**OELWEIN WEST ELEVATED WATER TANK
VALVE VAULT MODIFICATIONS**
CHANGE ORDER NO. 1

FIGURE: C	
REVISION	NO. DATE
DRAWN JAK	PROJECT NO. 3406-19A DATE 1-23-2020

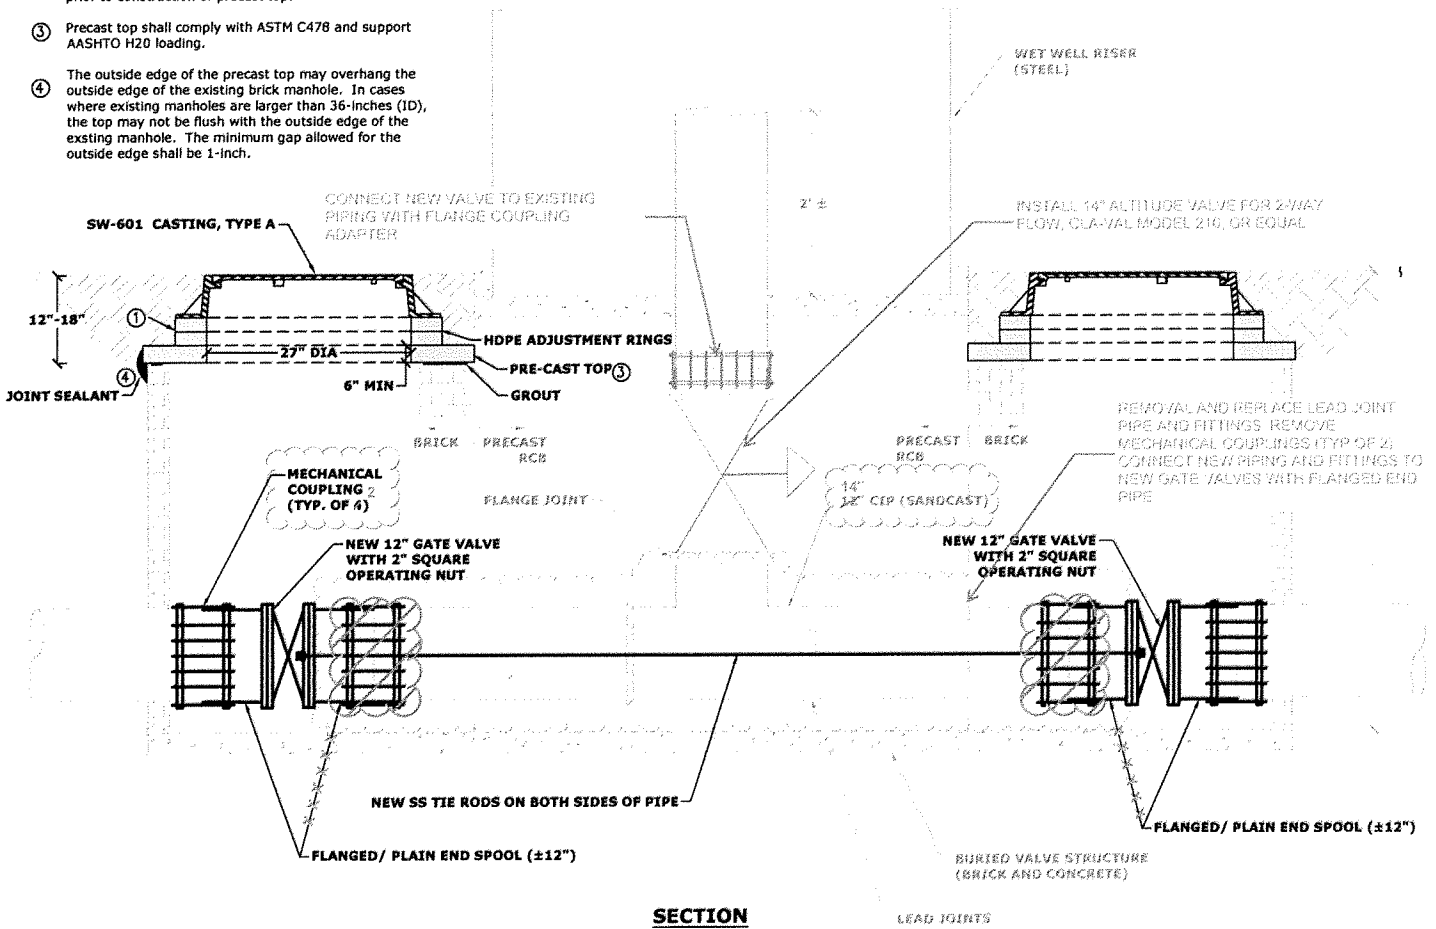
- ① Contractor shall use 1" butyle sealant rope as per ASTM C-990 and manufacturer's recommendations to achieve an air tight seal.
- ② Contractor shall verify existing brick manhole diameter prior to construction of precast top.
- ③ Precast top shall comply with ASTM C478 and support AASHTO H20 loading.
- ④ The outside edge of the precast top may overhang the outside edge of the existing brick manhole. In cases where existing manholes are larger than 36-inches (ID), the top may not be flush with the outside edge of the existing manhole. The minimum gap allowed for the outside edge shall be 1-inch.
